BODIE-STEWART SUBDIVISION

APPLICATION NUMBER 4 DATE October 5, 2017
APPLICANT Bodie-Stewart Subdivision
REQUEST Subdivision

DETAIL SITE PLAN

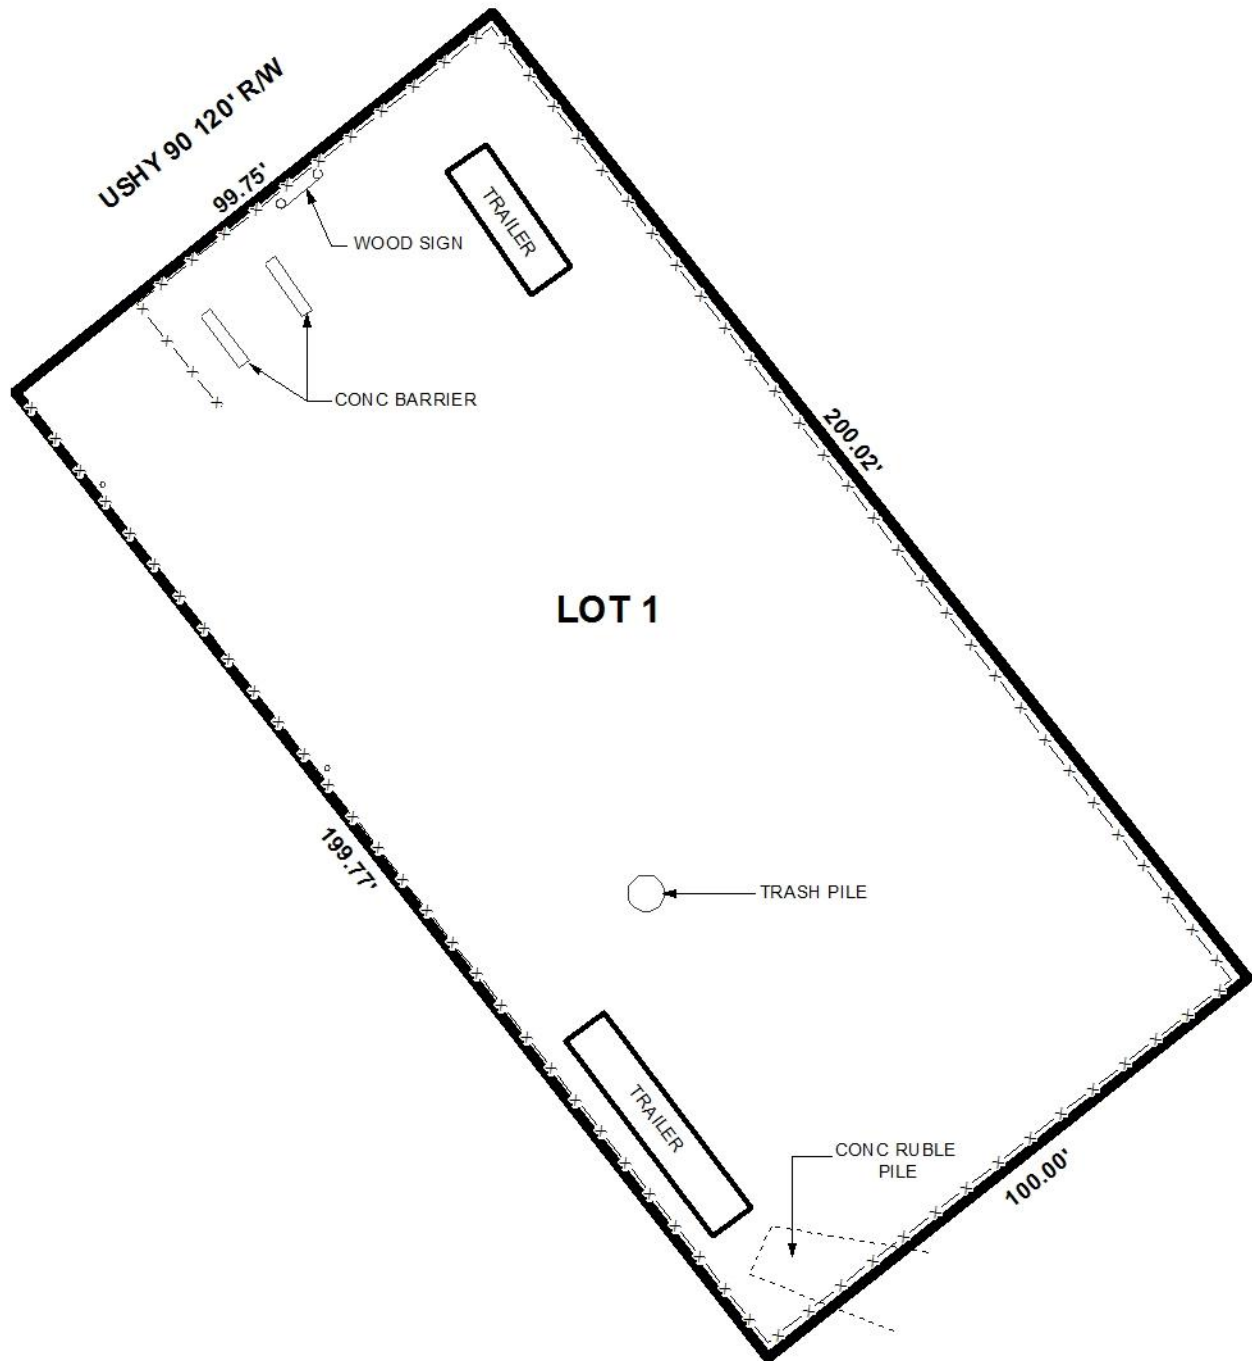
The proposed lot's size is only provided in acres on the preliminary plat. If approved, the Final Plat should be revised to indicate the lot's size in both square feet and acres; or, provision of a table on the Final Plat providing the same information may suffice.

The 25' minimum building setback is not illustrated on the preliminary plat per Section V.D.9. of the Subdivision Regulations. If approved, revision of the Final Plat to illustrate the 25' minimum building setback line along U.S. Highway 90 West should be required.

With regards to access management, a note should be placed on the Final Plat, if approved, stating the lot is limited to one curb cut to U.S. Highway 90 West, with any changes in its size, location or design to be approved by ALDOT and conform to AASHTO standards.

- 1) revision of the plat to illustrate the lot's size in both square feet and acres, or the provision of a table providing the same information;
- 2) revision of the plat to illustrate the 25' minimum building setback line;

- 3) placement of a note on the Final Plat stating the lot is limited to one curb cut, with any changes in its size, location or design to be approved by Traffic Engineering and conform to AASHTO standards;
